### **AMENDMENT NO.16**

### **EAST WANNEROO CELL 5**

**AGREED STRUCTURE PLAN NO.7**

# AMENDMENT NO.16 TO THE EAST WANNEROO CELL 5 AGREED STRUCTURE PLAN NO.7

ATTACHMENT 1
PROPOSED STRUCTURE PLAN MAP

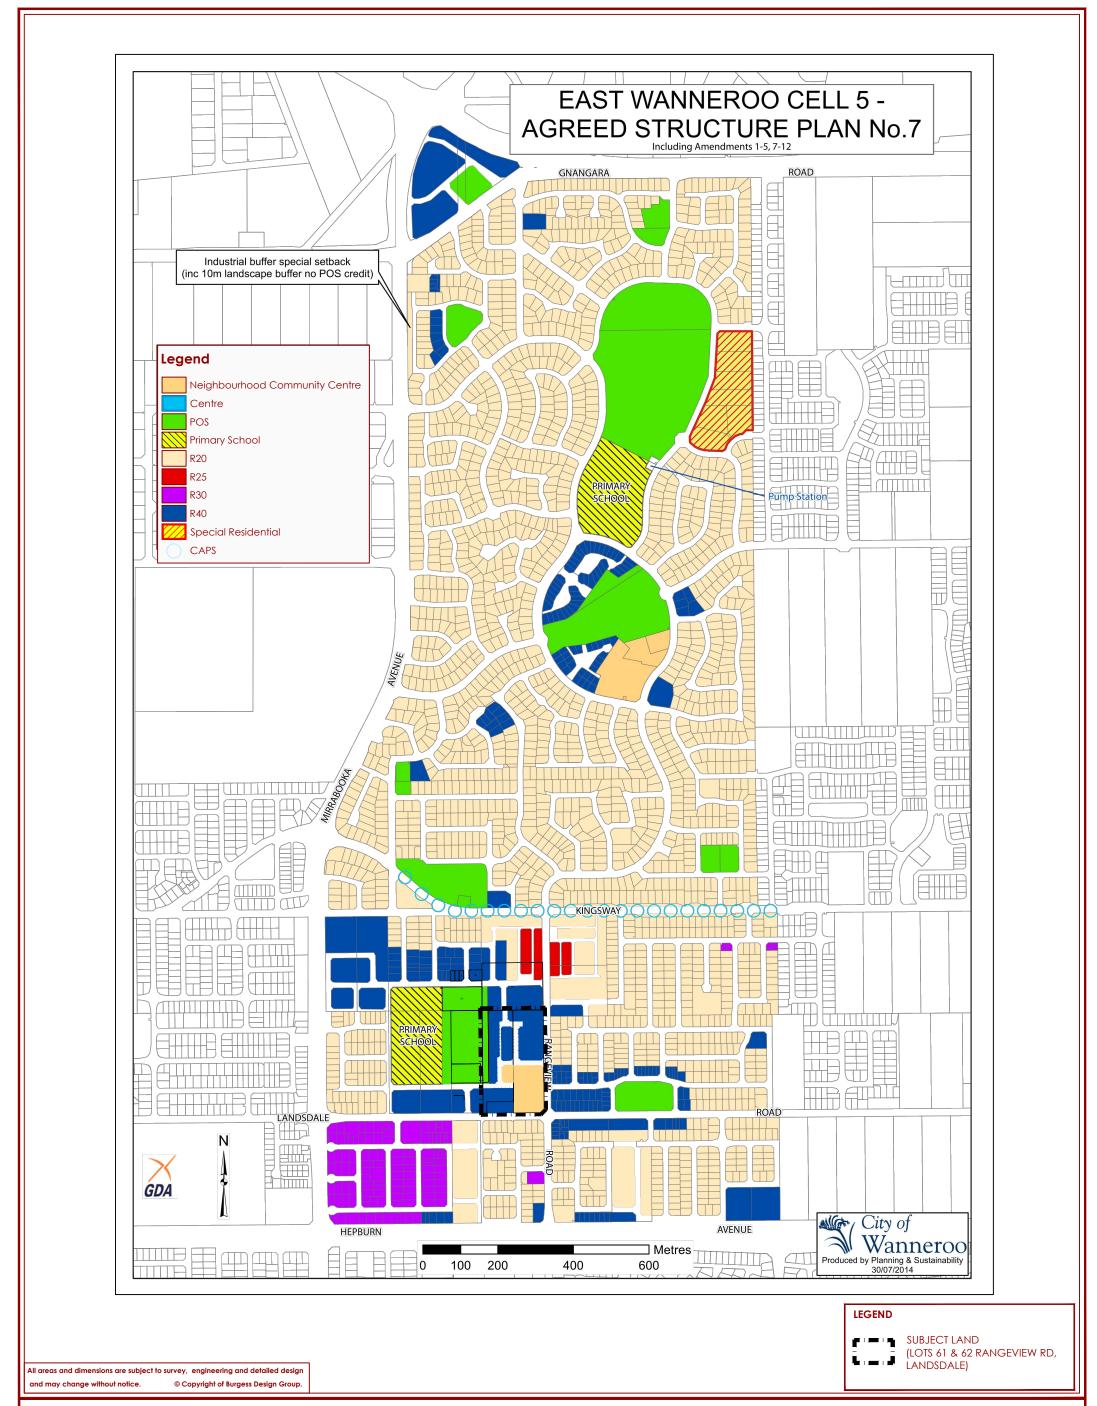
- Modifying the land use classifications of various portions of land shown as 'Neighbourhood Community Centre' within Lot 61 Landsdale Road, and Lot 62 Rangeview Road, Landsdale to 'Residential R40' as shown on Attachment 1 – Proposed Structure Plan Map.

- 2. Modifying the road layout over Lot 61 Landsdale Road, and Lot 62 Rangeview Road, Landsdale as shown on Attachment 1 Proposed Structure Plan Map.
- 3. Modifying the zoning of various portions of land zoned 'Centre' zone within Lot 61 Landsdale Road, and Lot 62 Rangeview Road, Landsdale to 'Residential Precinct' as shown on Attachment 2 Proposed Zoning Plan.

- Modify the land use classifications of various portions of land shown as 'Neighbourhood Community Centre' within Lot 61 Landsdale Road, and Lot 62 Rangeview Road, Landsdale to 'Residential R40' as depicted on Attachment 1 – Proposed Structure Plan Map.
- 2. Modify the road layout over Lot 61 Landsdale Road, and Lot 62 Rangeview Road, Landsdale to include a new north/south link through the former 'Community Neighbourhood Centre', a new connection to Rangeview Road, and remove the Harrogate Vista connection to Rangeview Road, as shown on Attachment 1 Proposed Structure Plan Map.

ATTACHMENT 2
PROPOSED ZONING PLAN

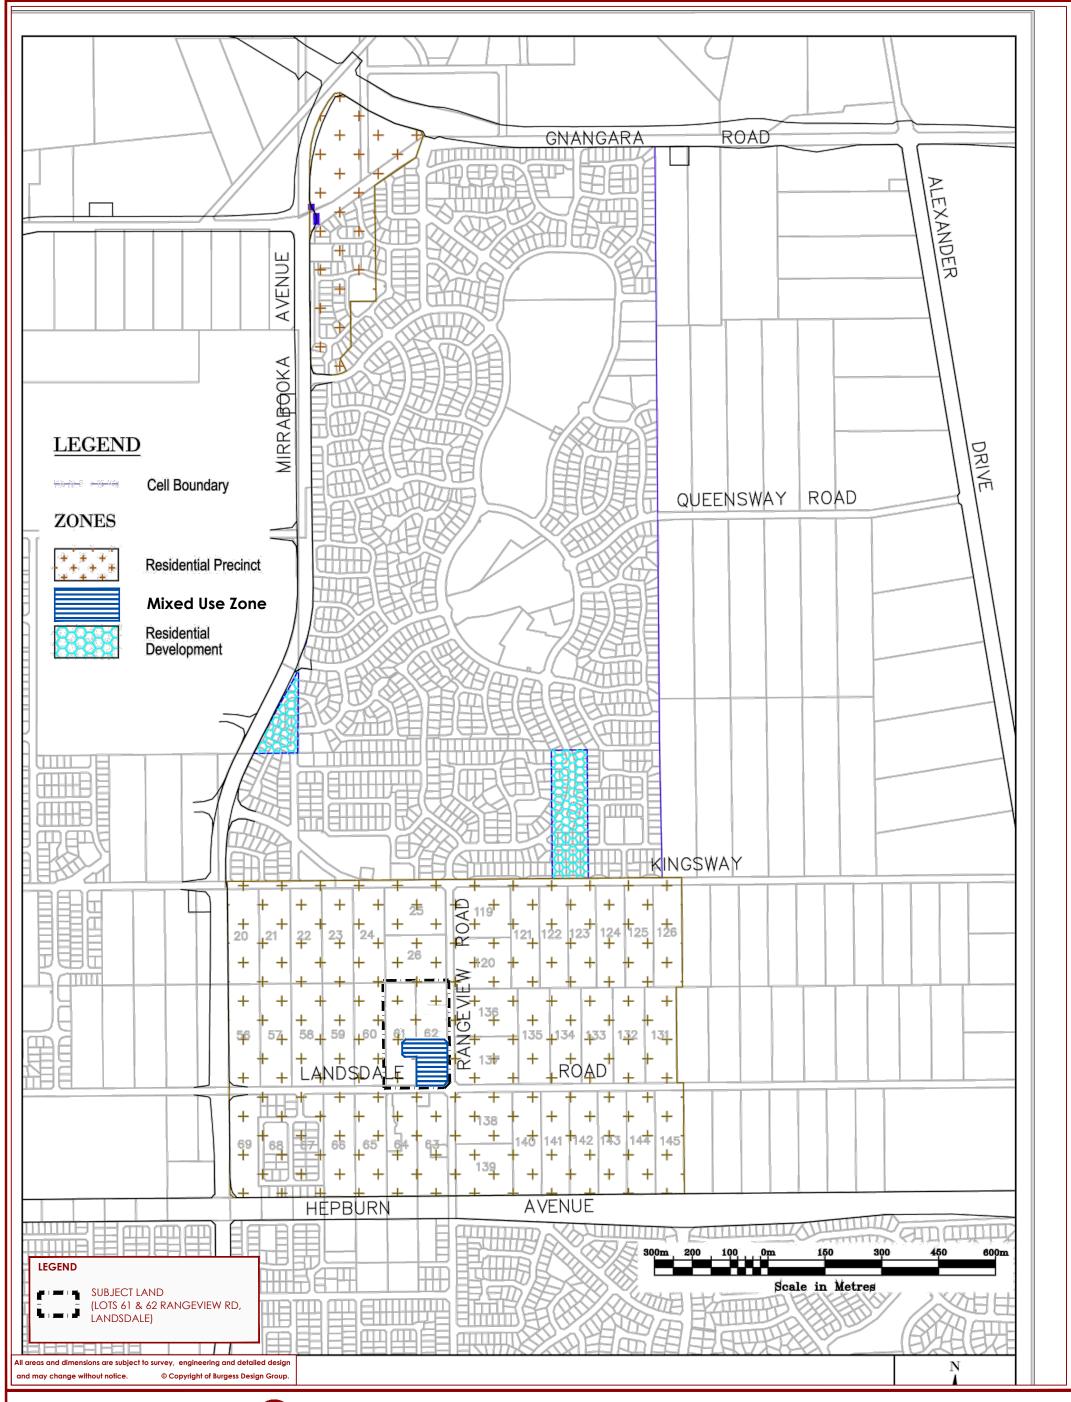
- 4. Modifying the zoning of various portions of land zoned 'Centre' zone within Lot 61 Landsdale Road, and Lot 62 Rangeview Road, Landsdale to 'Mixed Use' zone as shown on Attachment 2 Proposed Zoning Plan.

The amendment also proposes to modify the zoning over various portions of Lot 61 Landsdale Road and Lot 62 Rangeview Road, Landsdale shown as 'Centre' to 'Residential Precinct' and 'Mixed Use' as depicted in Attachment 2 – Proposed Zoning Plan.

ATTACHMENT 3
MODIFICATION COMPARISON PLAN

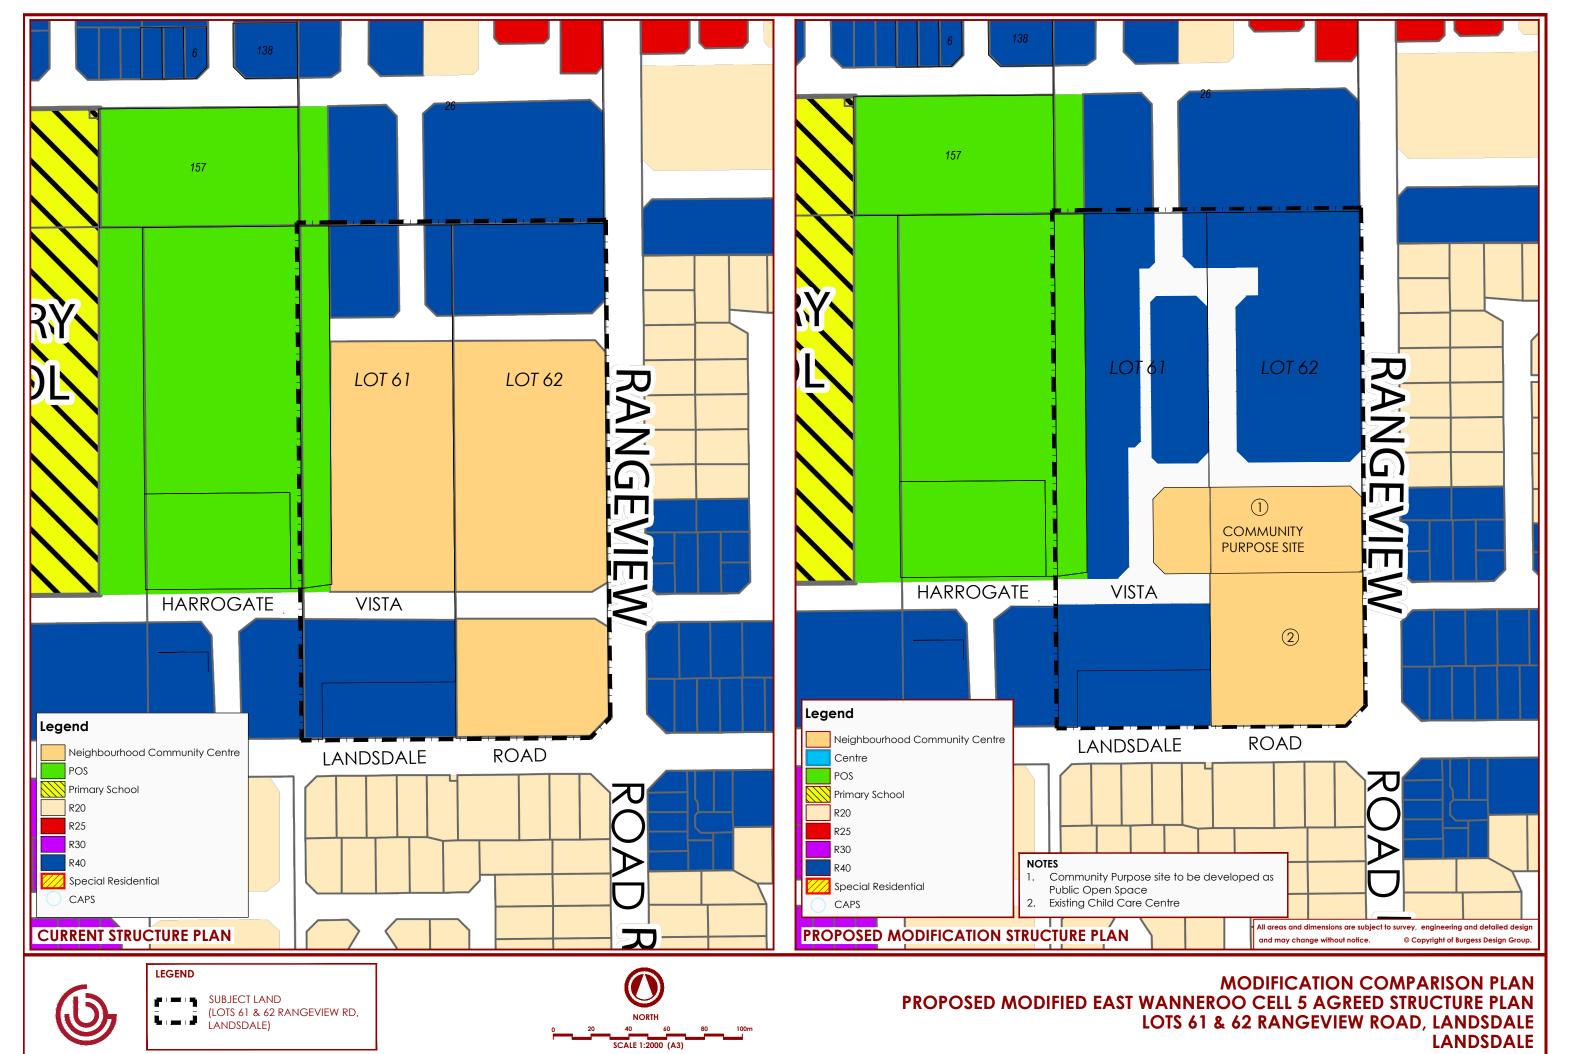
Under ASP7 the maximum net lettable area (NLA) for the Cell 5 Neighbourhood Centre (south) located on Lots 61 and 62 is 1,100m<sup>2</sup>. It is unlikely that a centre of this size could attract a major supermarket necessary to anchor other smaller retail and commercial tenants. As such, the proposed amendment seeks to reclassify the land to 'Residential R40' to reduce the amount of NLA on the site. It should be noted, the amendment will retain a portion (approximately 5,000m<sup>2</sup>) of the land identified as 'Community Purpose Site' on which the existing Child Care Centre is located (refer Attachment 3 – Modification Comparison Plan).
